AMENDMENT OF SOLICITATION/MODIFICATION OF CONTRACT			1. CONTRACT ID CODE J	PAGE OF PAGES 1 8
2. AMENDMENT/MODIFICATION NO. 0003	3. EFFECTIVE DATE 11-Jun-2012	4. REQUISITION/PURCHASE REQ. NO.		5. PROJECT NO.(If applicable)

AMENDMENT 0003

<u>ITEM NO</u>	<u>SCHEDULE OF SUPPLIES/SERVICE</u>	<u>AMOUNT</u>
0001	Renovate Hangar 728 Admin Spaces, MCLB Beaufort, SC per plans and specs provided by NAVFAC SE.	\$ _____

SHOWER CURB

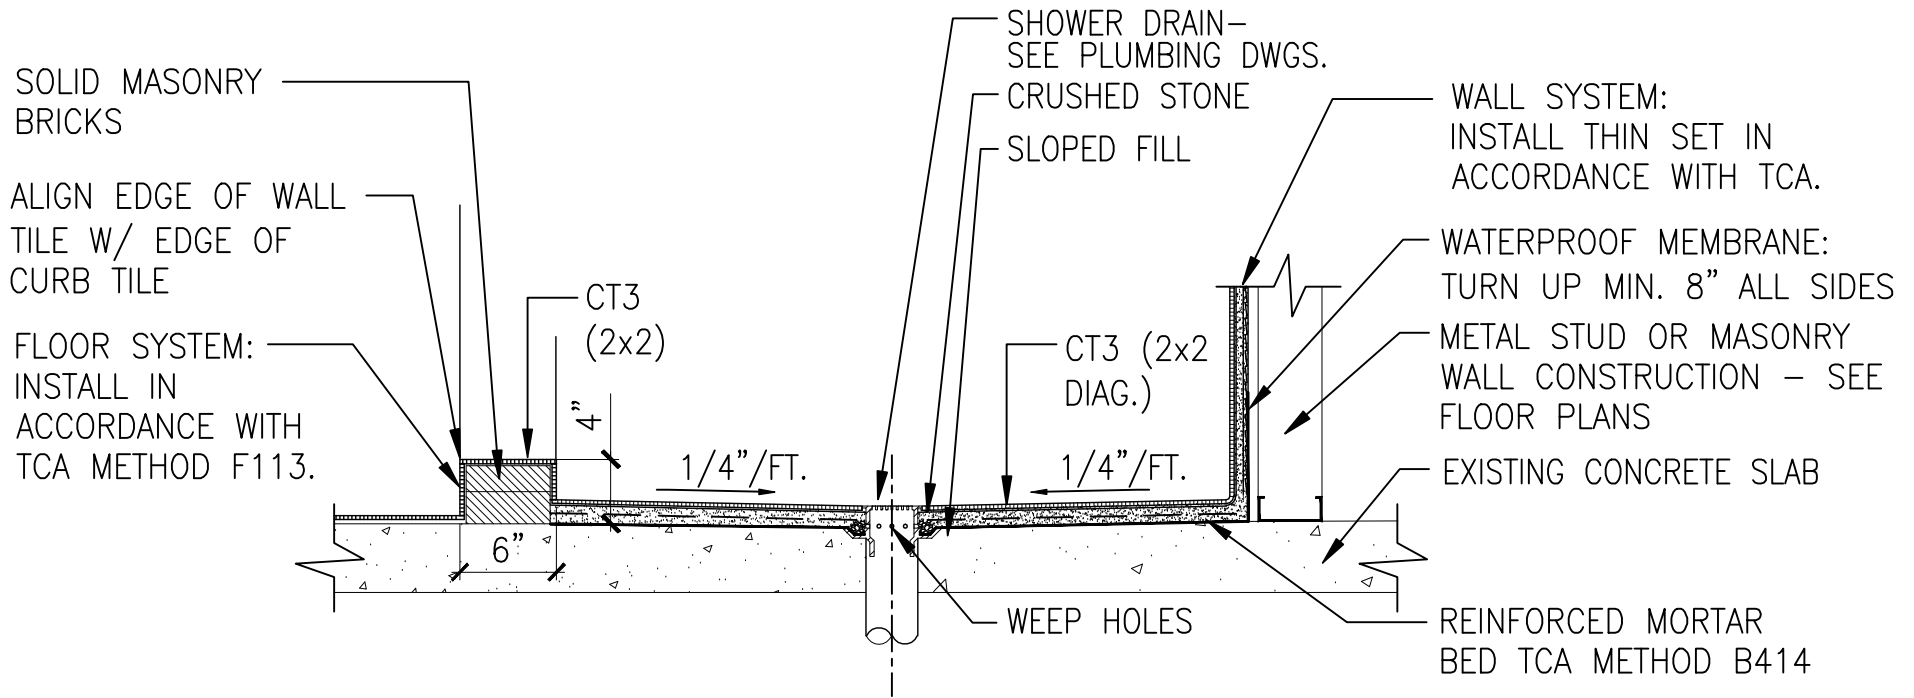
1. Add the following to NOTE 6: “Construct all showers with a typical floor curb. “
